Project	IEEE 802.16 Broadband Wireless Access Working Group < http://ieee802.org/16 >	
Title	Framework for Enabling Closed-loop MIMO for OFDMA	
Date Submitted	2005-01-26	
Source(s)	<p>Wonil Roh, JeongTae Oh, Chan-Byoung Chae, Kyunbyoung Ko, Hongsil Jeong, Sung-Ryul Yun, Seungjoo Maeng, Jaeho Jeon, Jaeyeol Kim, Soonyoung Yoon</p> <p>Samsung Electronics Co., Ltd.</p> <p>Erik Lindskog, Harold Artes, Djordje Tujkovic, Kamlesh Rath, Andreas Bergkvist, V. Shashidhar, B. Sundar Rajan, Rahul Vaze, Bob Lorenz, Babu Mandava, A. Paulraj, Aditya Agrawal</p> <p>Beceem Communications, Inc.</p> <p>Young-Ho Jung, Seung Hoon Nam , Jaehak Chung, Yungsoo Kim, Sung-Jin Kim, Hojin Kim</p> <p>Samsung Advanced Institute of Technology</p> <p>Wen Tong, Peiying Zhu, Ming Jia, Dongsheng Yu, Hua Xu, Jianglei Ma ,Mo-Han Fong, Hang Zhang, Brian Johnson</p> <p>Nortel Networks</p> <p>Qinghua Li, Xintian Eddie Lin, Sumeet Sandhu, Shilpa Talwar, Randall Schwartz, Alexey Davydov, Uri Perlmutter, Nageen Himayat, Minnie Ho</p> <p>Intel Corporation</p> <p>Bin-Chul Ihm, Yongseok Jin, Jinyoung Chun, Kyuhyuk Chung</p> <p>LG Electronics</p> <p>Kevin Baum, Mark Cudak, Tim Thomas, Fred Vook Xiangyang (Jeff) Zhuang</p> <p>Mot

Figure 231c - Mapping of MIMO coefficients [for quantized precoding weight](#) for enhanced fast MIMO feedback payload bits

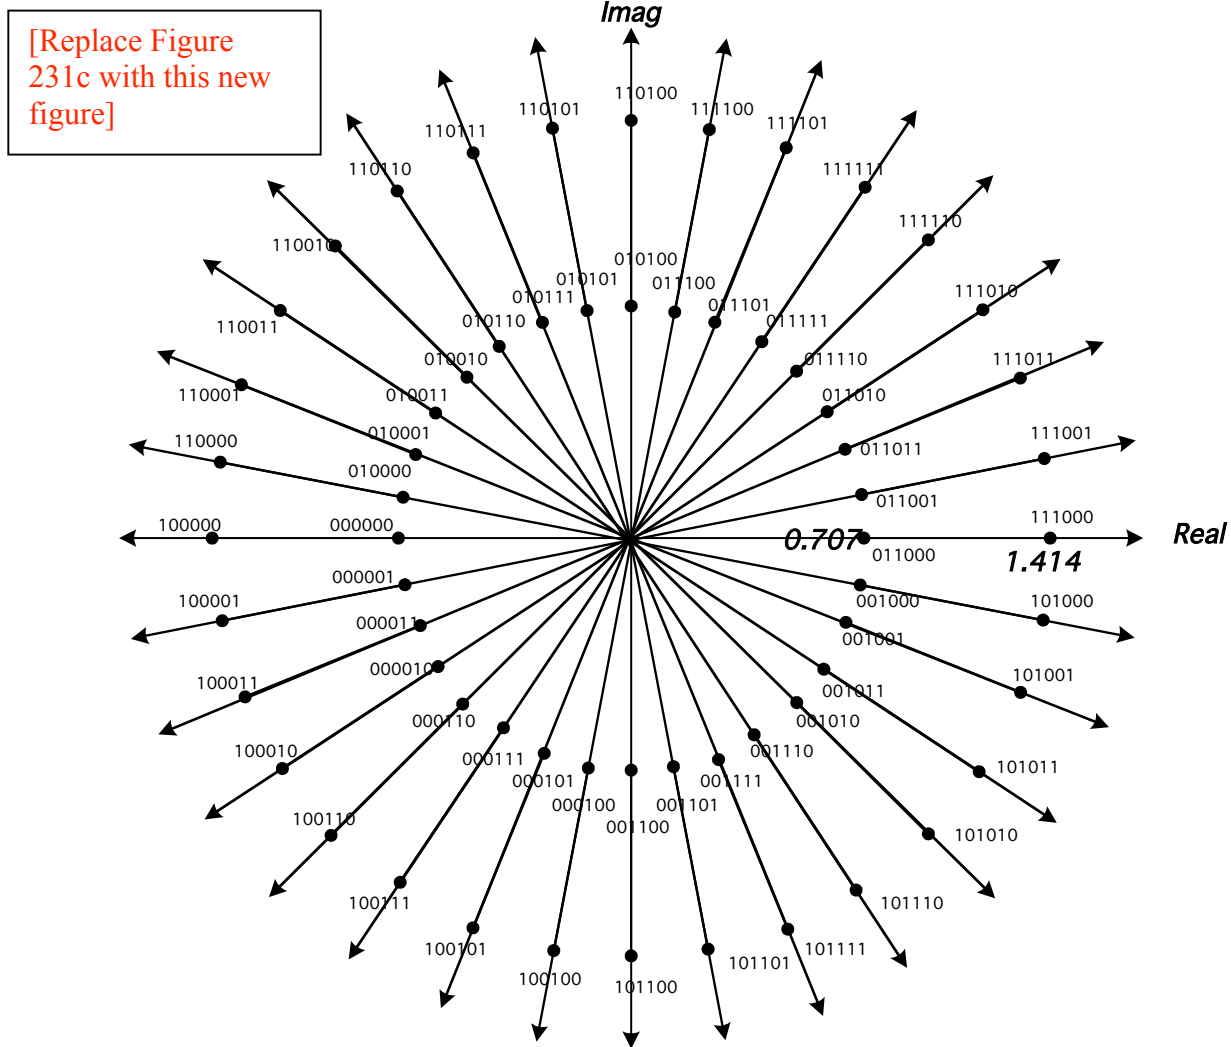
8.4.5.4.10.6 Fast MIMO Feedback of Quantized Precoding Weight for Enhanced FAST_FEEDBACK Channel

When the FAST_FEEDBACK subheader Feedback Type field is '01' or '10', or the CQI Feedback Type field in the MIMO Compact DL-MAP IE() (see 6.3.2.3.43.6.7) is 011, or the CQI Feedback Type field in CQICH_Enhanced_Alloc_IE() (see 8.4.5.4.~~15~~+2) is 011, the MSS shall report the MIMO coefficient the BS should use for best DL reception (~~see 8.4.8.1.6~~). The mapping for the complex weights is shown in Figure 231c, and the SS shall construct the 6 CQI bits with 0 as the MSB and the mapped code as the remaining LSBs. For this type of feedback, if N is

[the number of BS transmit antennas, then \(N-1\) CQICH shall be allocated to the SS and SS shall report the desired antenna weights of antenna 1 through N-1 based on antenna 0.](#)

Figure 20d—MIMO Channel Feedback header with CID field

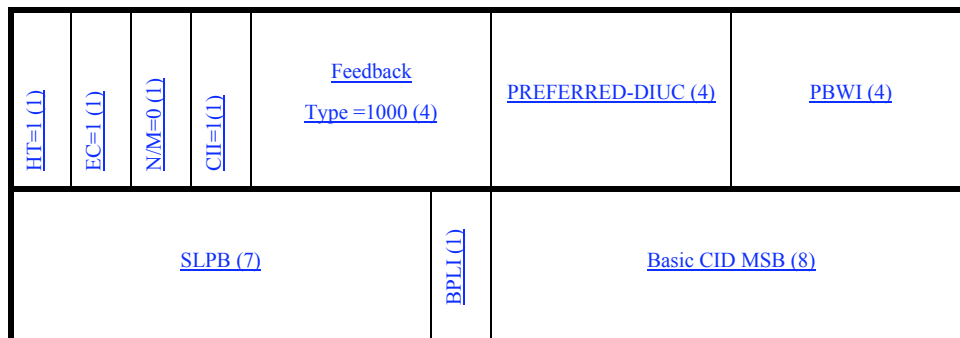
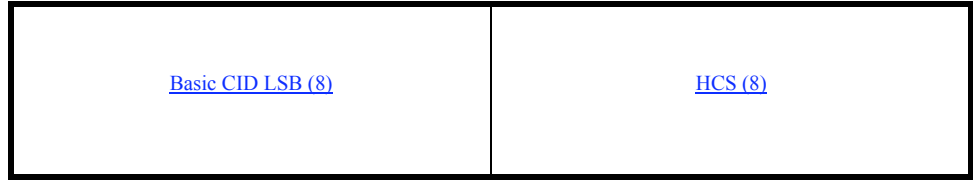
6.3.2.1.4.3 MIMO Channel Feedback header

The MIMO Channel Feedback header is used for MSS to provide DL MIMO channel quality feedback to the BS. The MIMO Channel Feedback header can be used to provide a single or composite channel feedback. The MIMO Channel Feedback header with or without basic CID field is illustrated in Figure 20d and Figure 20e respectively.

- a) The length of the header shall always be 6 bytes.
- b) The TYPE field shall be "1000"
- c) PREFERRED-DIUC indicates the preferred DIUC suggested by the MSS
- d) PBWI provides the size of the preferred bandwidth which can be used for DIUC transmission
- e) SLPB points to the starting preferred bandwidth location. Combining with PBWI field, BS knows the exact size and location of the preferred bandwidth in the channel
- f) BPRI can be used to rank up to 4 preferred burst profiles within the DL channel
- g) CTI provides coherent time information
- h) AI can support up to 4 antennas
- i) MI suggests the preferred STC/MIMO Matrix for the MSS
- j) CT/COI can support two types of COI report

Figure 1112 H-ARQ Enabled Vertically Encoded 2x2 MIMO System

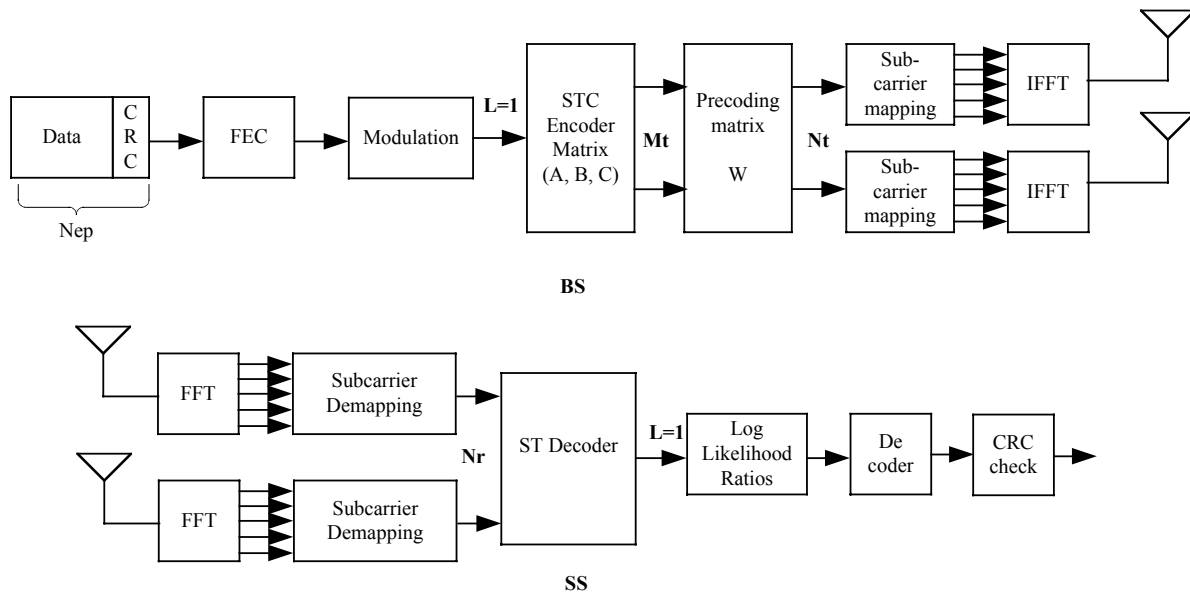
Some clarification is made on burst mapping for H-ARQ when multiple MIMO layers are transmitted on the same physical resource. The multiple layer transmission is enabled when spatial multiplexing (SM) schemes are employed with multiple modulation and coding blocks implemented for each spatial layer. We call it horizontal encoding (HE) and this mode enables adaptive rate control for each spatial layer. The other class of spatial multiplexing schemes is called vertical encoding (VE) and it features a common modulation and coding block. Transmit diversity (TD) can be also regarded as single layer technique. [Figure 1](#)~~Figure 1~~[Figure 2](#) shows an example of 2x2 VE MIMO system, whereas [Figure 2](#)~~Figure 2~~[Figure 3](#) illustrates that of 2x2 HE MIMO system. In both figures, L equals the number of layers, Mt the number of STC output streams, Nt the number of BS transmit antennas, and W denotes the precoding matrix. Their relations according to the current standard are tabularized in [Table 5](#)~~Table 5~~[Table 5](#).

In both Figure 1 and Figure 2, when there is no precoding matrix at Tx, M_t becomes the number of transmit antennas. In Table 1, the existing open-loop matrices (A, B, or C) are noted and the superscript ¹ indicates the applicability of the antenna grouping technique.
